# 1966 - 1967 Corvette: Service Bulletin: Crankshaft to Water Pump Drive Belt Failure

**Subject:** Crankshaft to Water Pump Drive Belt Failure  
**Model and Year:** 1966 - 1967 Corvettes with 427 CU. IN. Engine and Air Conditioning  
**Source:** Chevrolet Service Technical Bulletin  
**Bulletin No:** 67-T-26  
**Section:** VI  
**Date:** Sept. 26, 1967

FIG. 1

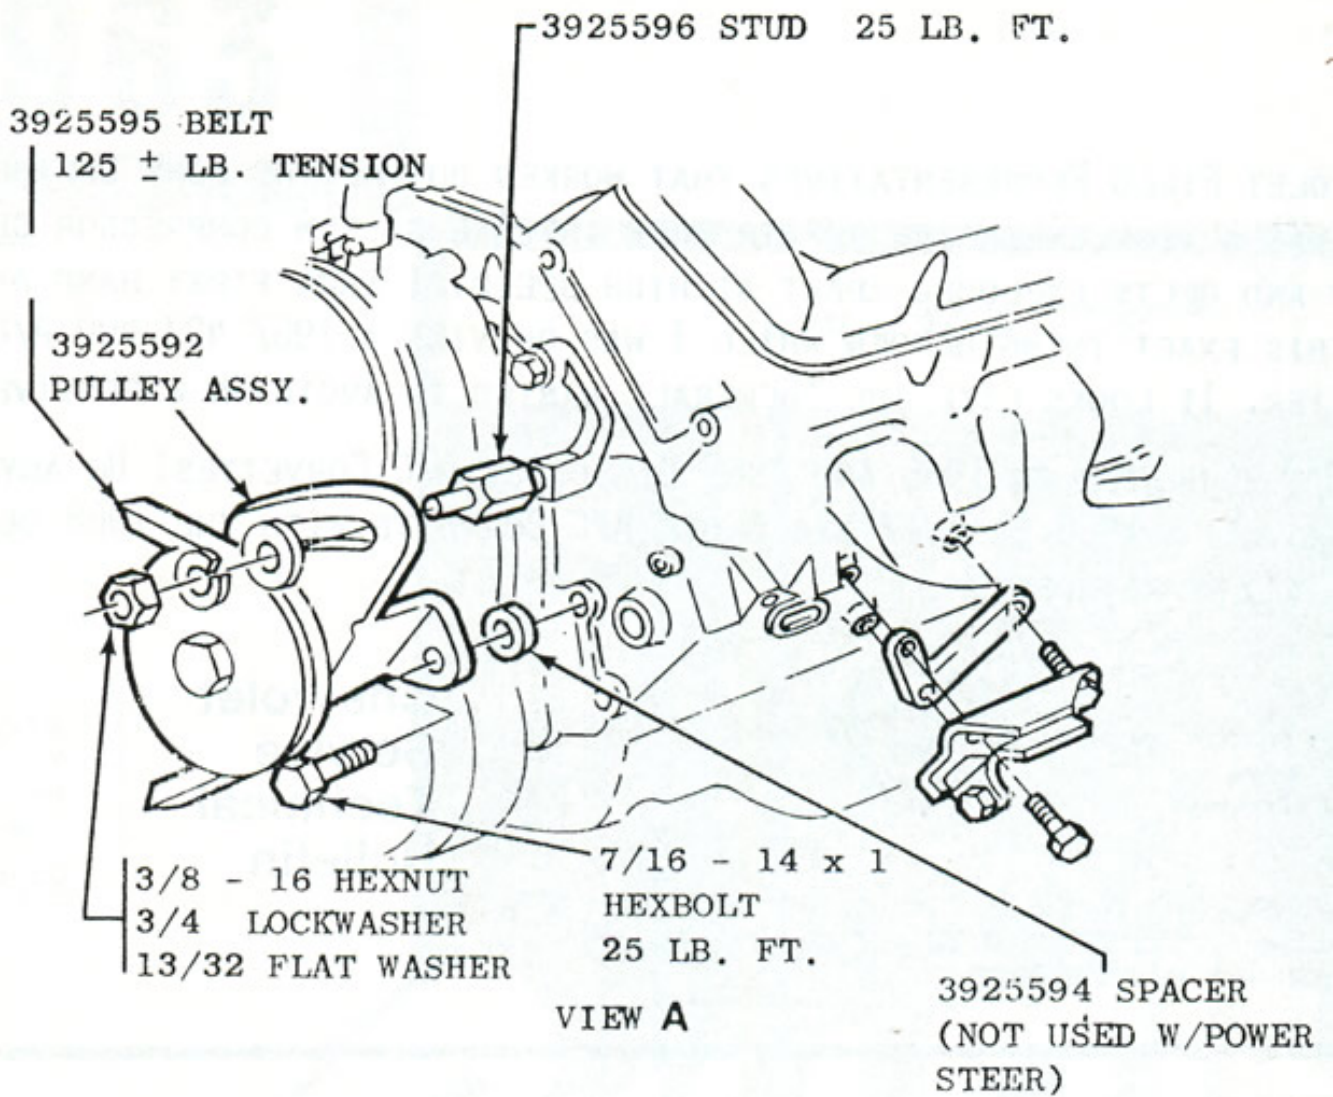
Reports have been received of crankshaft to water pump drive belt failures on 1966 and 1967 Corvettes equipped with 427 cubic inch engine and air conditioning. The belt failure occurs when the air conditioning compressor stalls under high head pressure after extreme hot soak conditions. With the compressor stalled, the water pump and the drive belt between the crankshaft and water pump also stall. As the crankshaft pulley continues to rotate, the crankshaft to water pump drive belt fails due to overheating and wear.

To permit belt tension adjustment between the crankshaft and water pump, 1968 Corvettes equipped with 427 cubic inch engine and air conditioning will incorporate an idler pulley shown in Figure 1.

In service, a similar idler pulley and longer drive belt can be installed to permit belt tension adjustment and correct the condition of belt slippage and wear. Parts information and installation instructions are illustrated in Figure 1

3925595 BELT  
125 ± 5 LB. TENSION
